CITY OF ALBUQUERQUE

Re: Eubank Animal Clinic

Traffic Circulation Layout

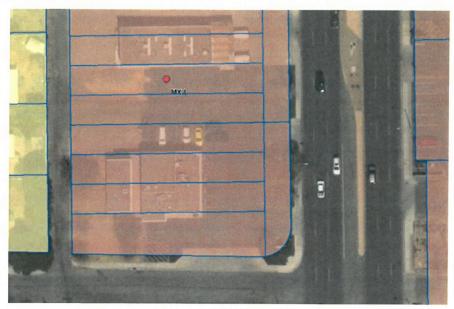
- Shared Site acces: driveways that straddle property lines, or are entirely on one propertybut are to be used by another property, shall have an access easement. Please include a copy of your shared access agreement with the adjacent property owner.
- 2. According to the following picture from AGIS, This property is divided to differebt lots. We have a rule that says parking spaces can not be bisected by lot lines. And in the east side of the property, there is parcel that has been vacated. I am not sure what's happening with that parcel and who does it belong to?

Please show lot lines on TCL.
